Decision re Mann Town Highway Access Road Permit Application

I am writing to request reconsideration and clarification of two (2) provisions of the Memorandum of Decision and Driveway Permit with Conditions and Limitations issued to Andrew Mann on October 13, 2023.

Request for Clarification and Reconsideration of the Driveway Area Dimensions

SHEET TITLE: SLIDE #4 - 17' WIDE X 20' DEEP HELD TO NORTH EXTENT

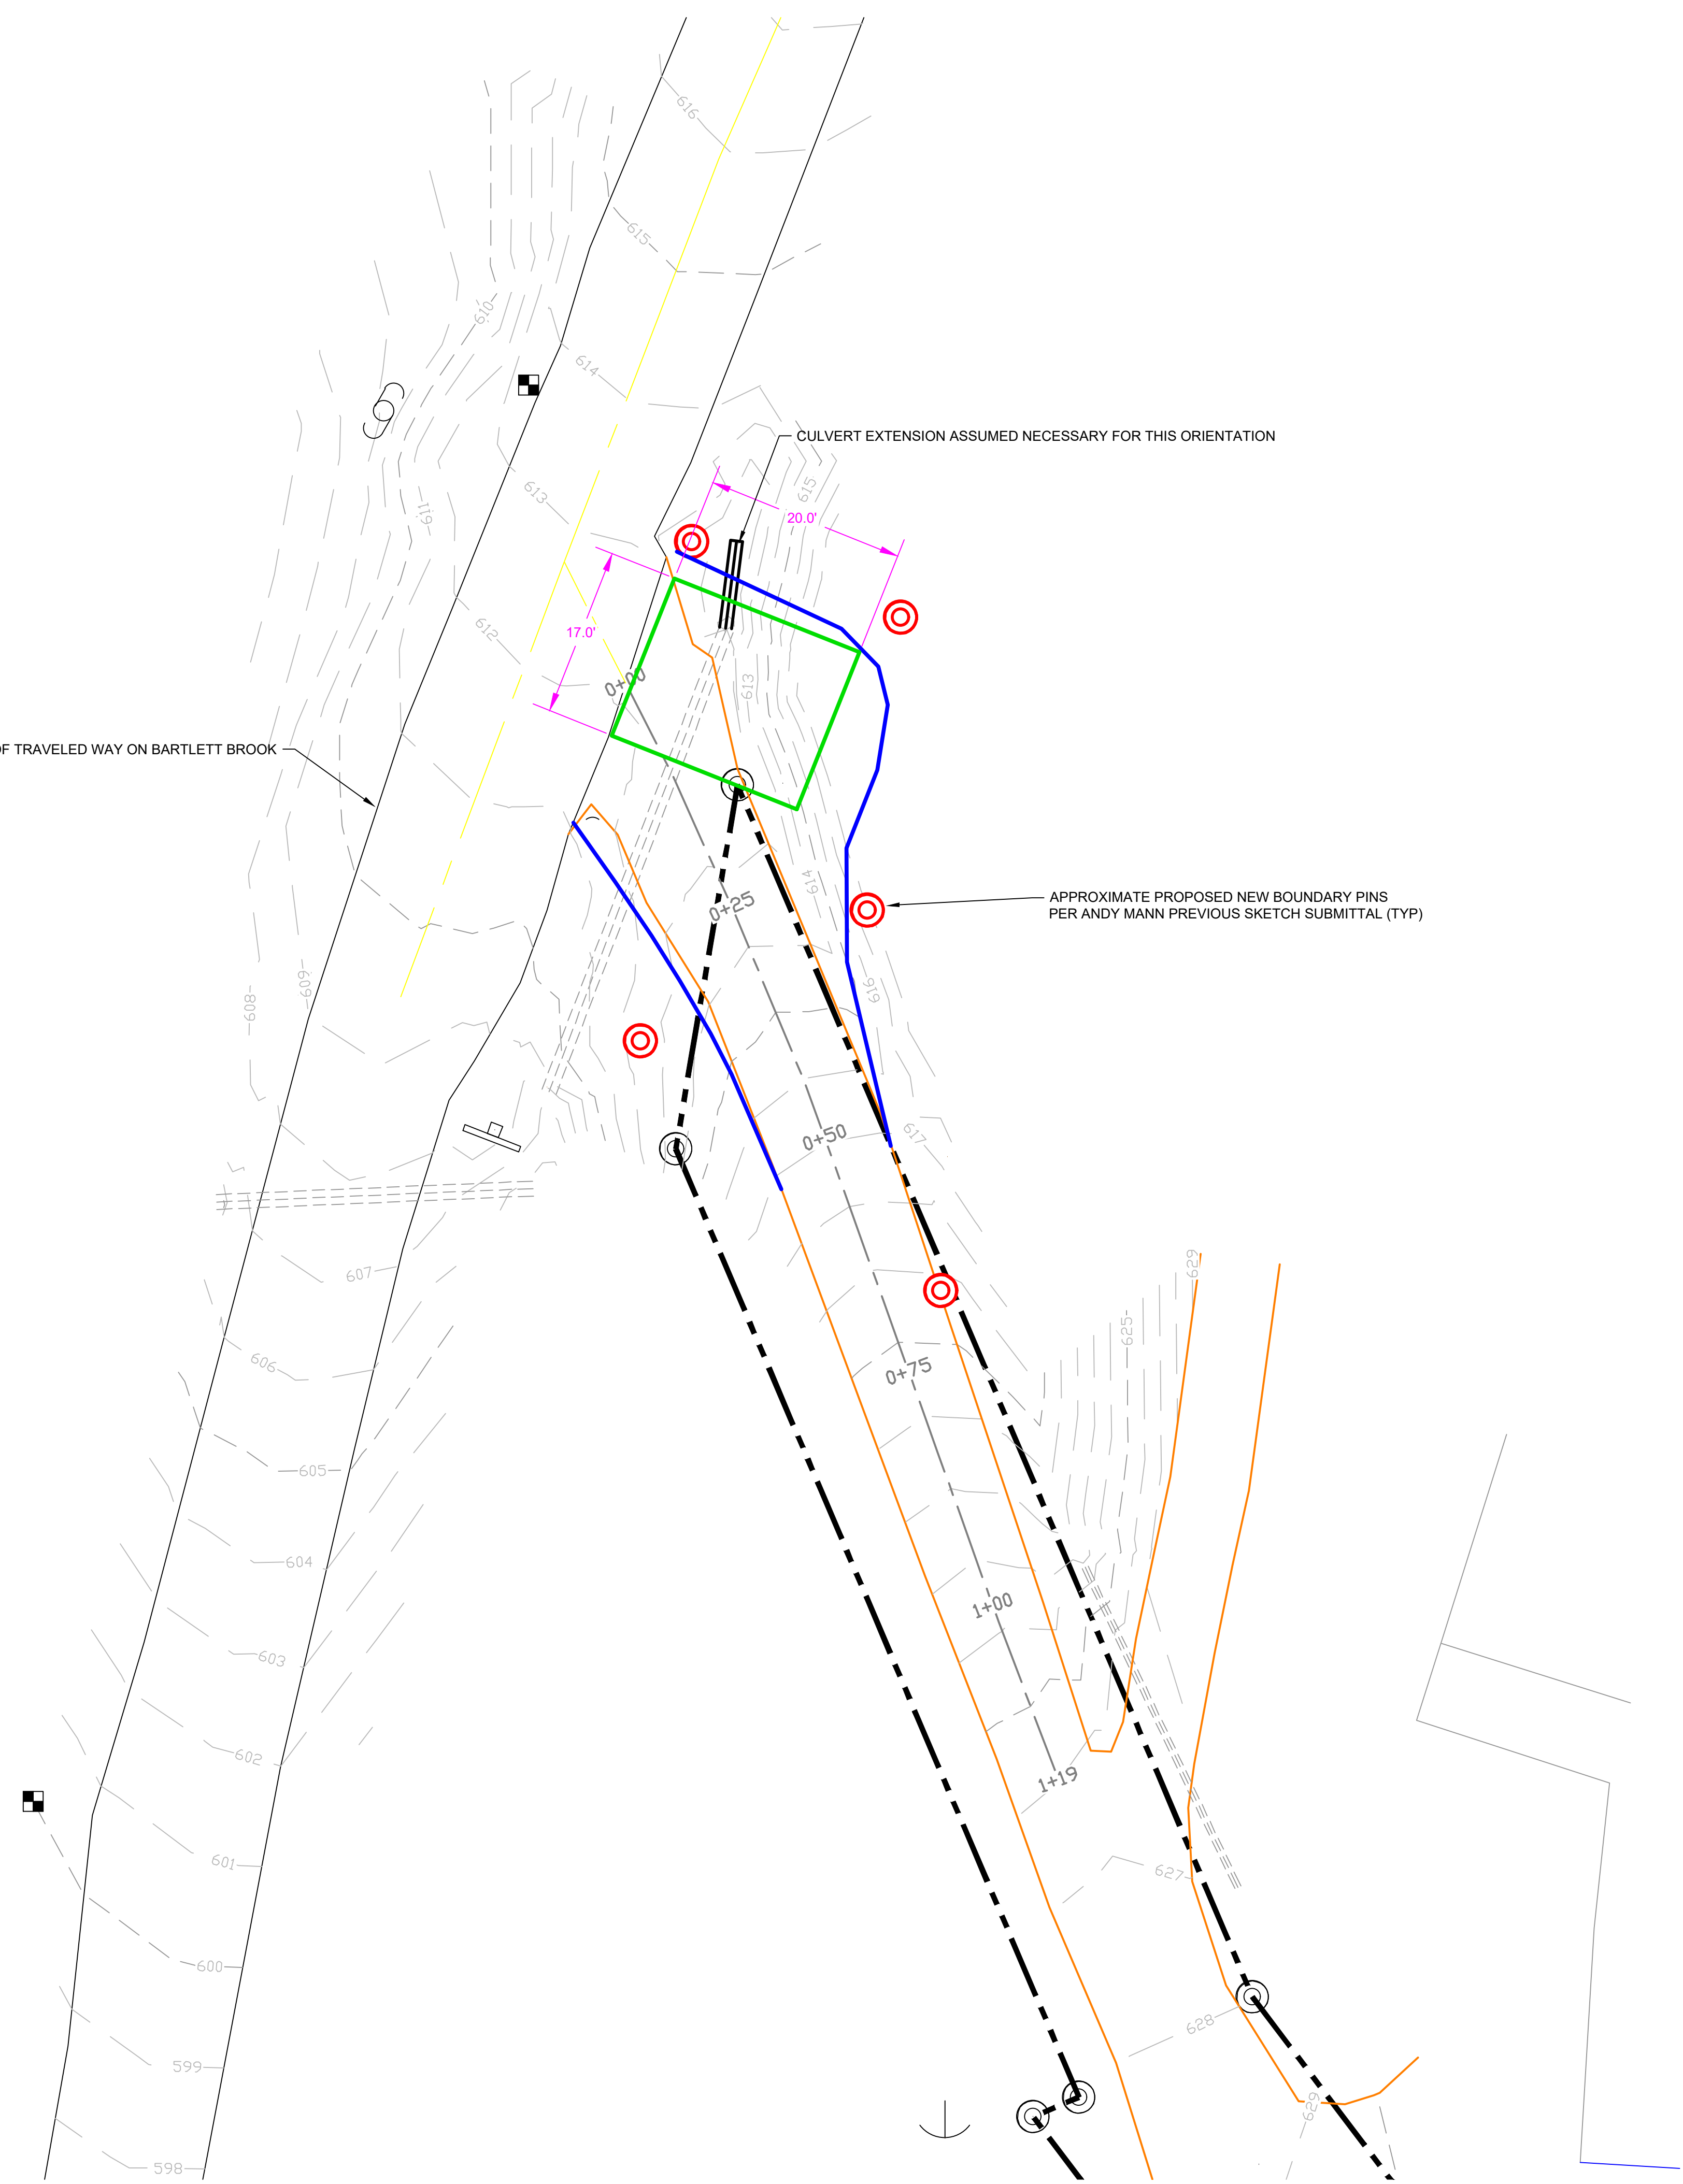
Alternatively, if either a 17' or 19' box is located at the northern end of the Revised Site Plan (as set forth in Slide 4 and Slide 6) abutting the proposed (and approved) Dinsmoor Road travel way to the north, the southern end of the driveway entrance is located almost in the middle of the proposed travel way which is inconsistent with Mr. Mann's testimony and potentially changes what the Select Board contemplated in Conditions F and Condition G given that it is unclear what work would be contemplated between the edge of the green box and the southern edge of Mr. Mann's proposed travel way in his site plan.

SHEET TITLE: SLIDE #5 - 15' WIDE X 20' DEEP HELD TO SOUTH EXTENT

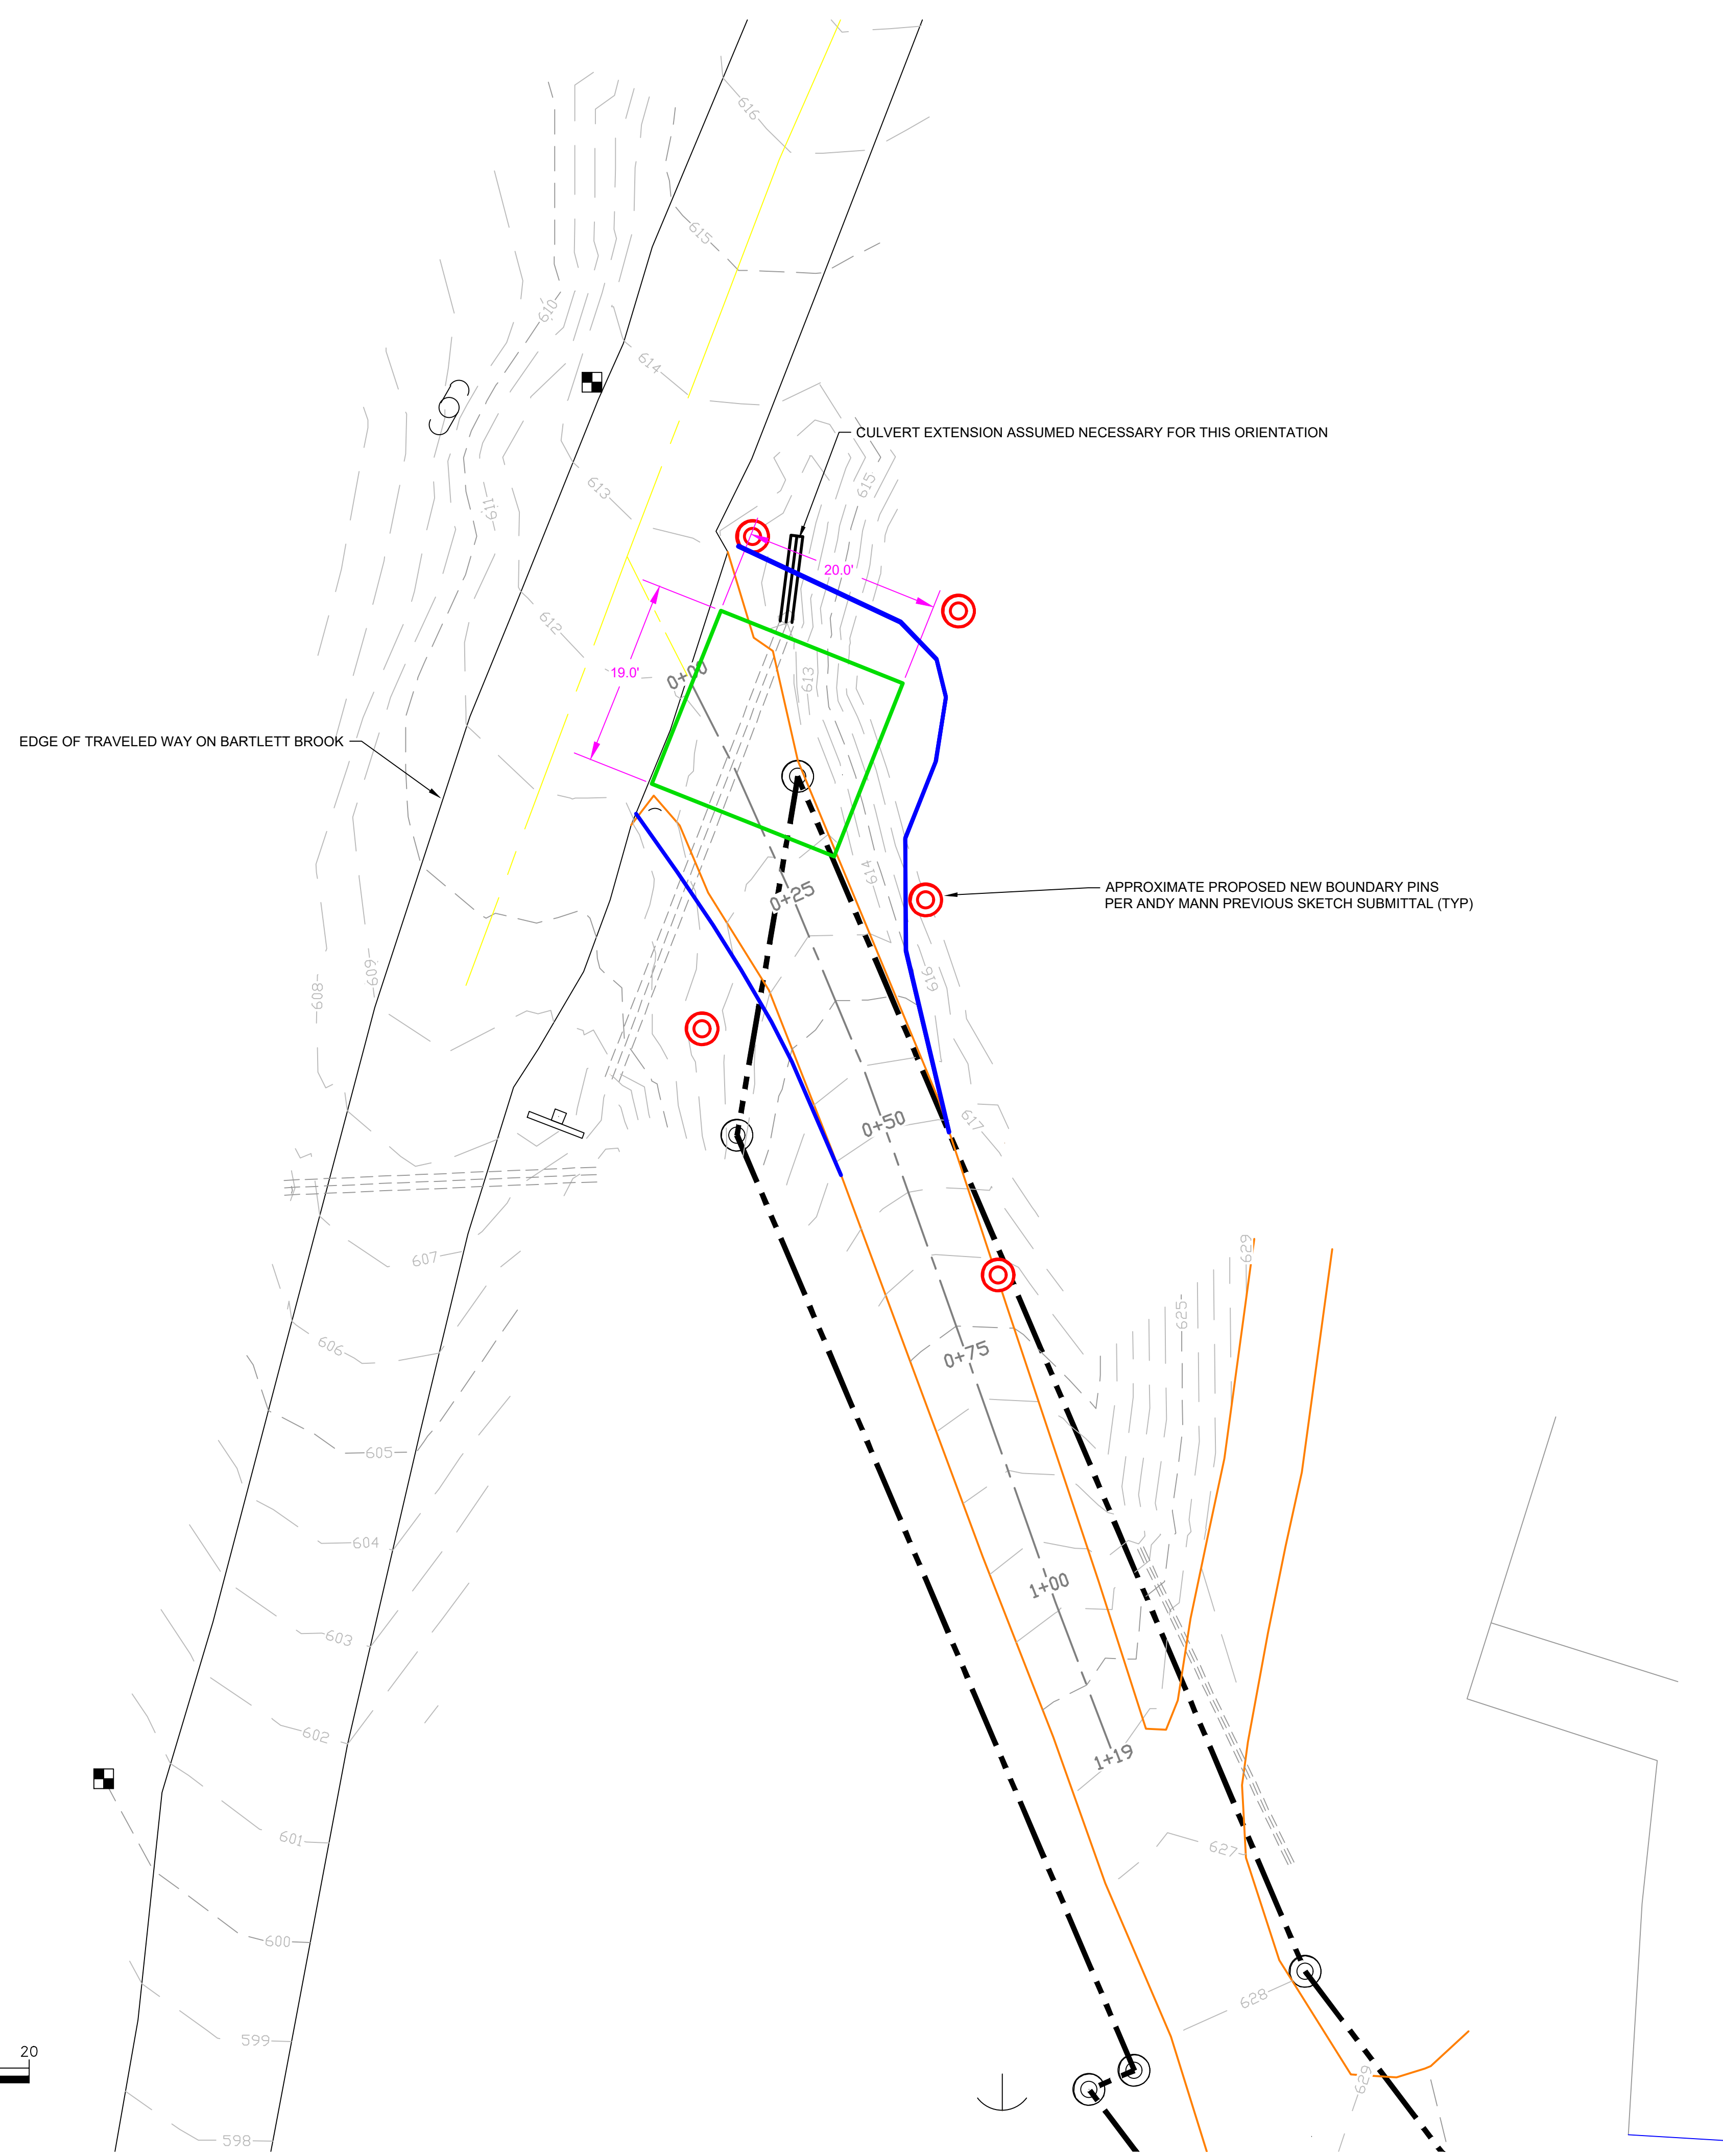
By way of illustration and comparison, attached are Slides 3 through 6. These CAD slides illustrate the location of the proposed driveway box if Mr. Mann is bound by the language of his permit application (i.e., between 17' and 19' feet wide and pitching away from the road 1' over the first 20'). As the Select Board will note, whether 17' or 19' feet wide (as set forth in Slide 3 and Slide 5), if the driveway area defined in the permit application is located at the southern end of Mr. Mann's site plan abutting his southern boundary of the proposed (and approved) Dinsmoor Road travel way, there appears to be little or no need for the extension of the culvert at the north end of Dinsmoor road, a topic of discussion and expectation at the September 13 hearing (14:42 and 28:32). The location of the green box at that point in the CAD slides is consistent with his own testimony (21:24) that the project is 85% finished and that "[t]he only part that is really going to change is the upper left hand corner [on the Revised Site Plan] where we still got to cut it back."
